PROJECT COMMENTS

PROJECT NUMBER: SP2022-045
PROJECT NAME: Site Plan for Alumni Bar & Grill
SITE ADDRESS/LOCATIONS: 906 S GOLIAD ST

CASE CAPTION: Discuss and consider a request by Allen Anderson of Adlor Enterprises, LLC for the approval of a Site Plan for a Restaurant on a 1.1308-acre parcel of land identified as Lot 1, Block B, Jack Canup Addition, City of Rockwall, Rockwall County, Texas, zoned Planned Development District 62 (PD-62) for General Retail (GR) District, addressed as 902 & 906 S. Goliad Street [SH-205], and take any action necessary.

SITE PLAN

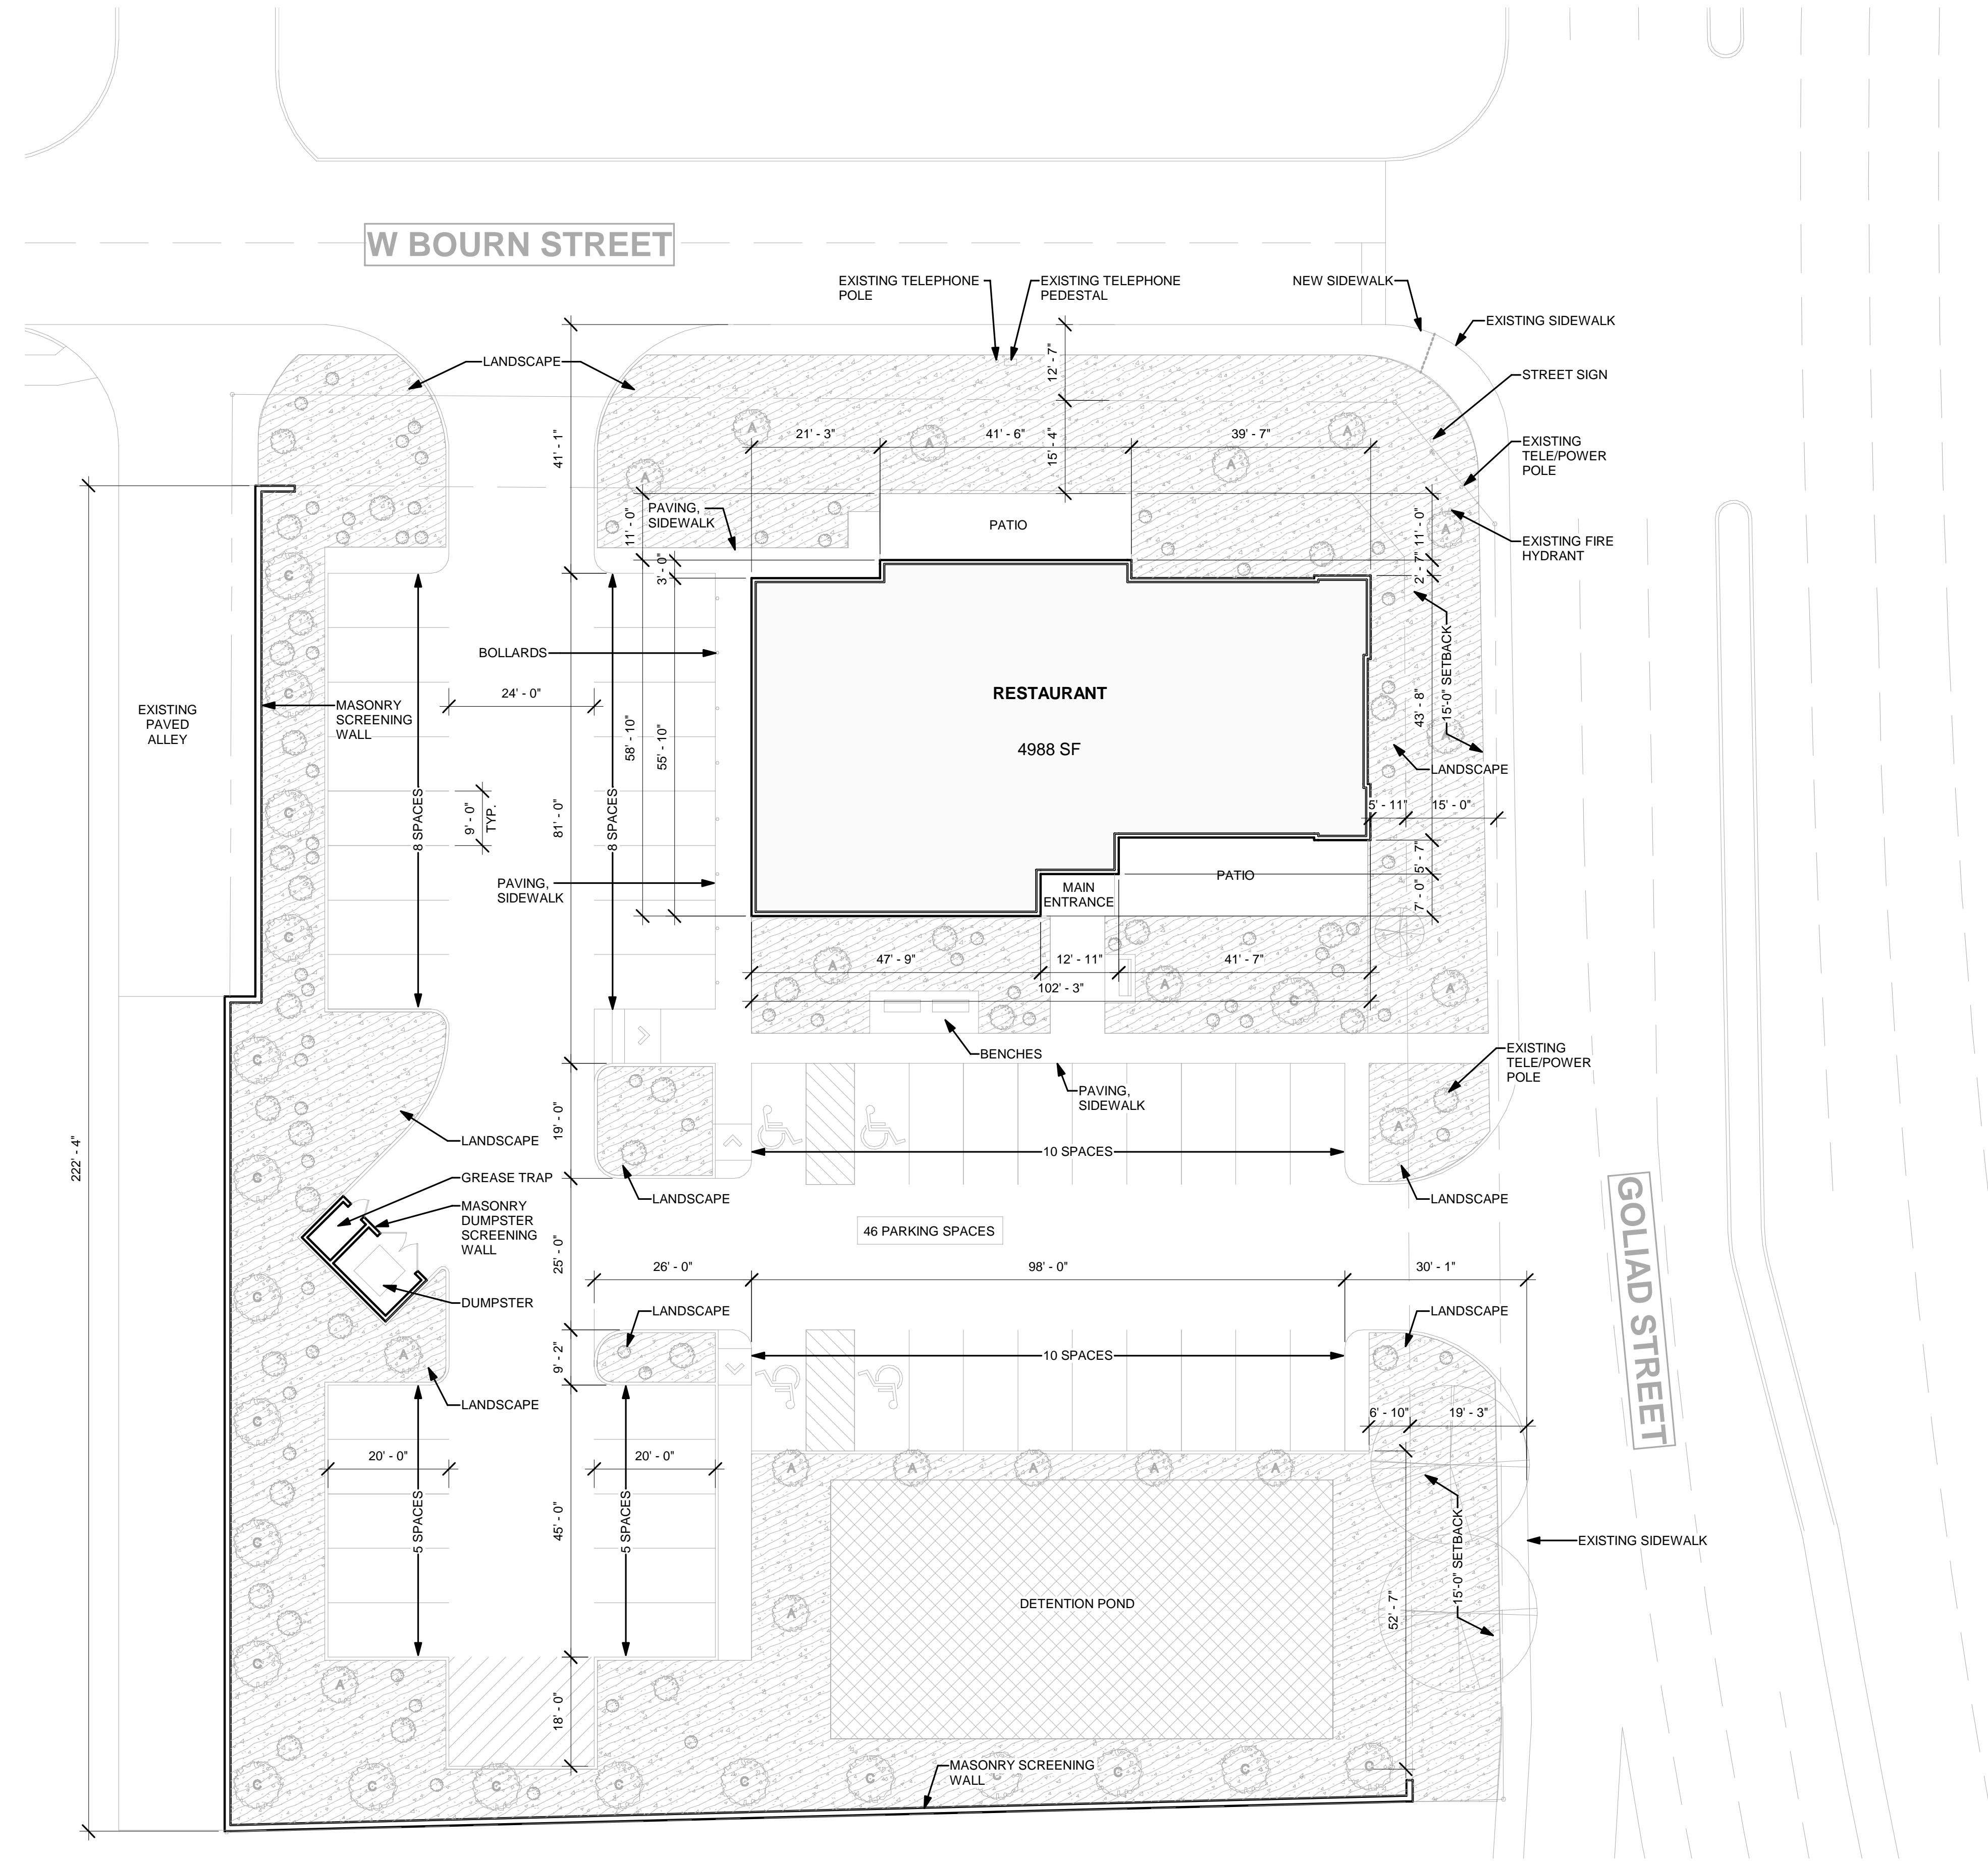
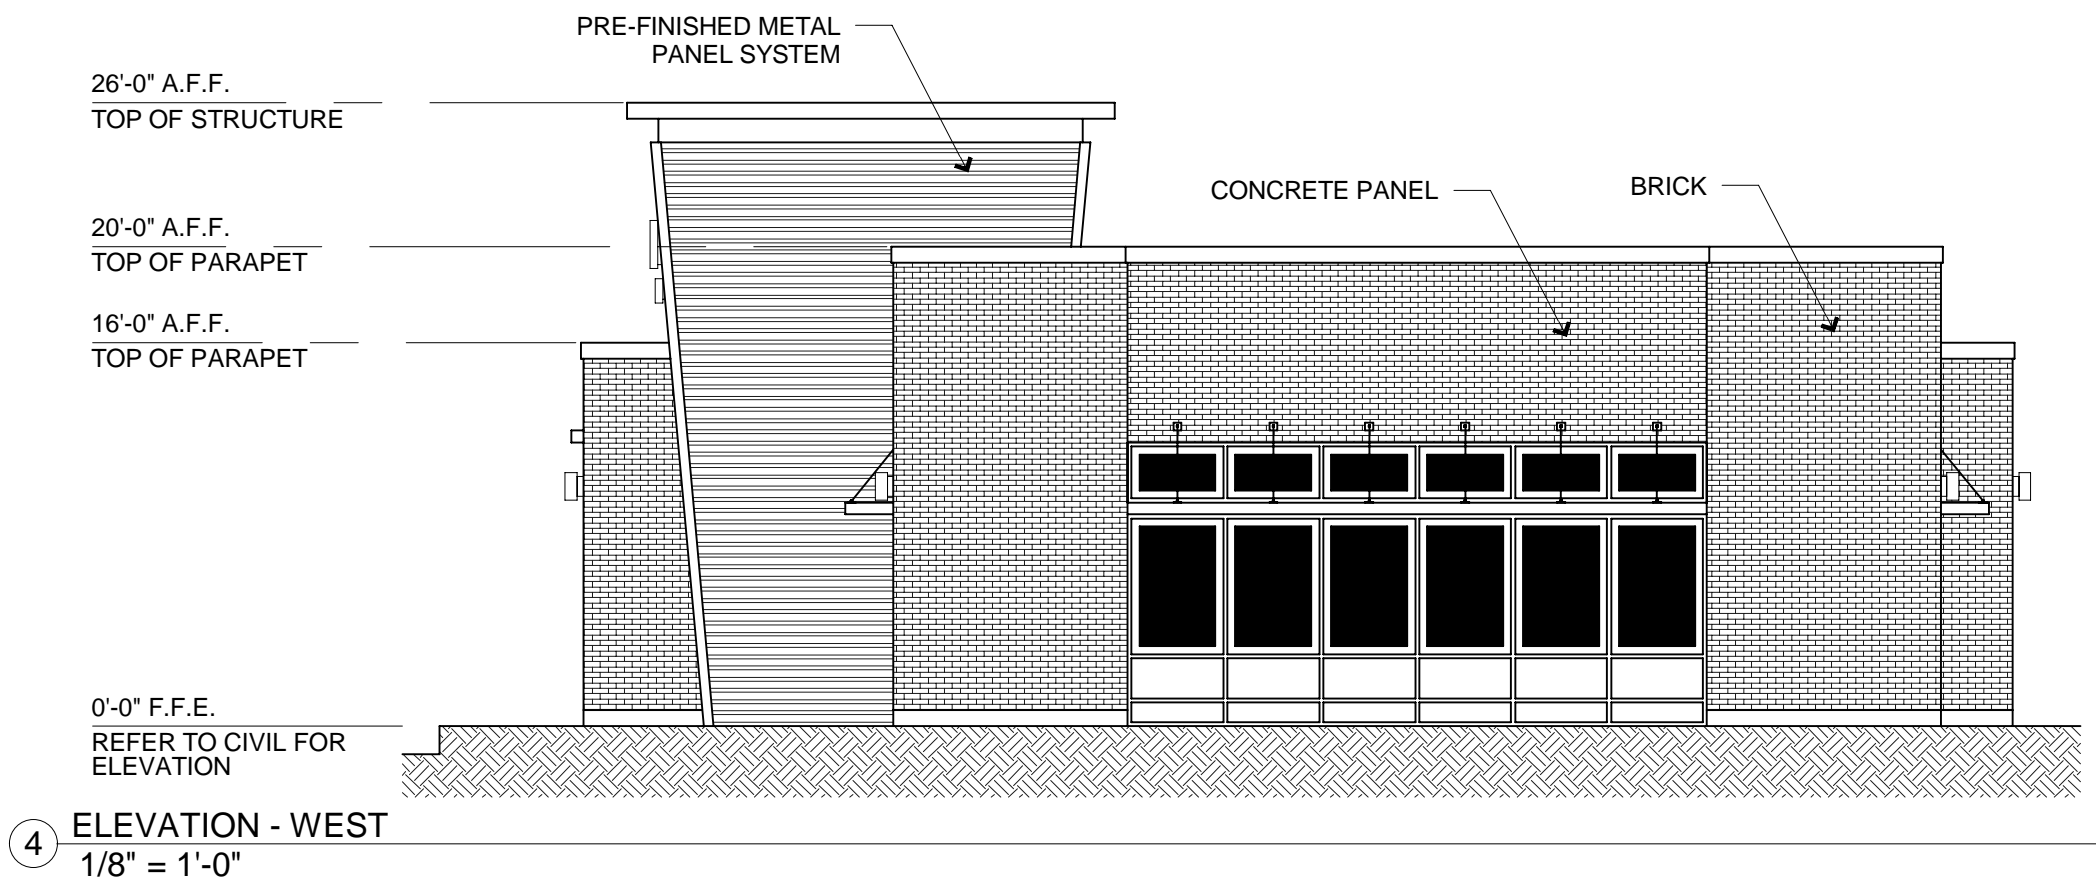
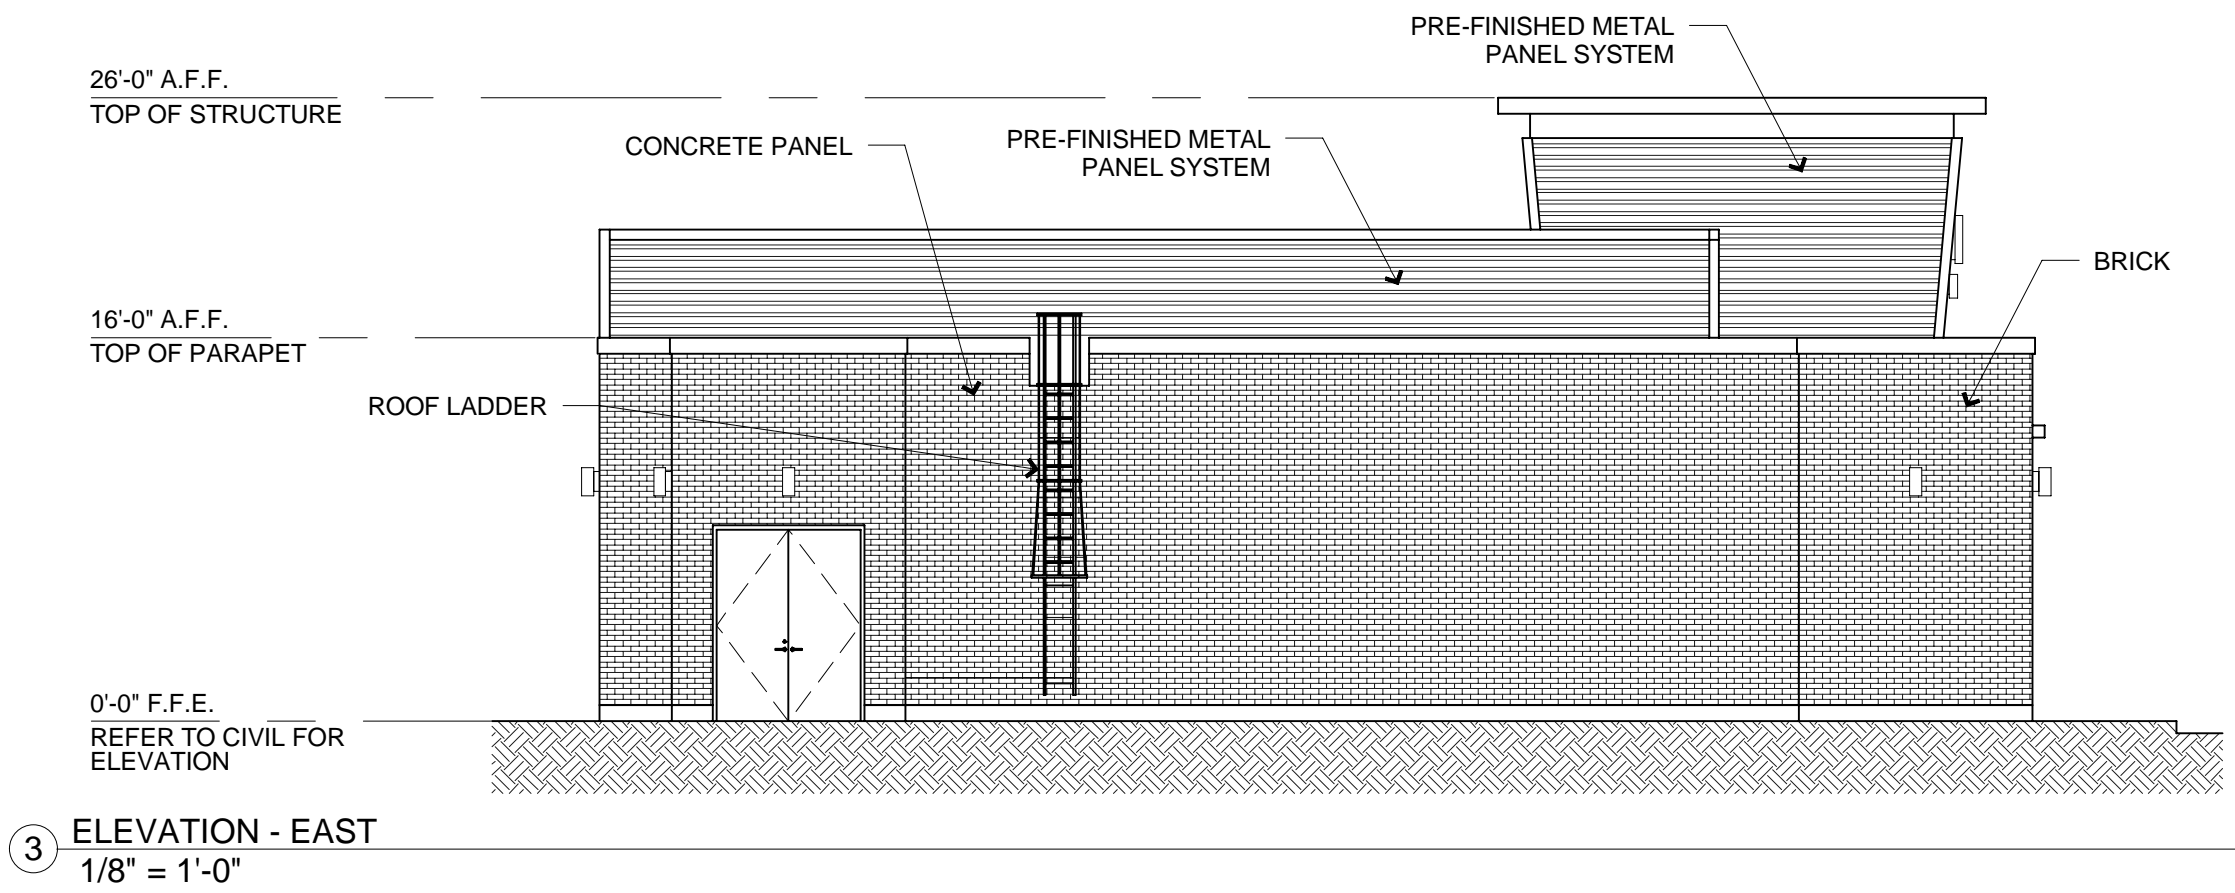
M.8 Site Plan:

1. Please provide the total lot area in acreage and square footage. (Subsection 03.04. B, of Article 11)
2. Please provide the perimeter dimensions of the site. (Subsection 03.04. B, of Article 11)

3. Please indicate the building setbacks. (Subsection 03.04. B, of Article 11)
4. Please label the drive radii and drive widths. For a building under 30-feet the radii must be 20-feet. The drive widths must be a minimum of 24-feet. (Subsection 03.04. B, of Article 11)

5. Please label the fire lanes as Fire Lane, Public Access, and Utility Easement. (Subsection 03.04. B, of Article 11)
6. The parking requirement is 1 per 100 square feet. In this case you need 50 parking spaces not including any patio seating, which is 1 space per 4 seats. Just considering the building you are short 4 spaces. To remedy this, without major site changes, the building could be reduced in size and/or a few spaces might be gained near the dumpster enclosure. (Table 5, Article 06)

7. Indicate the height of the proposed masonry screening wall. Also provide a wall detail that depicts the height, materials, and design. (Subsection 08.02. F, of Article 08)

8. Indicate any ground mounted utility equipment and the subsequent screening. (Subsection 01.05. C, of Article 05)
9. Indicate any roof mounted utility equipment and crosshatch it on the building elevations. (Subsection 01.05. C, of Article 05)

10. Dumpster Screening. Trash/Recycling enclosures shall be four (4) sided. These receptacles shall be screened by a minimum six (6) foot, solid masonry dumpster enclosure that utilizes the same masonry materials as the primary building and incorporates an opaque, self-latching gate. The minimum enclosure area shall be 12'x10'. A minimum of 6" bollards will be required at potential impact zones and the pad site shall be paved to city standards. 5-gallon evergreen shrubs must be planted around the enclosure. (Subsection 01.05. B, of Article 05)

- 08/25/2022: - Must show existing/proposed utilities.
- Sidewalk to be 2' from ROW/Property line.
 - 100' min required driveway variance needed.
 - Parking adjacent to the building to be 20x9' minimum.
 - Must have 15'x64' parking turnaround. Striped and signed "No Parking"
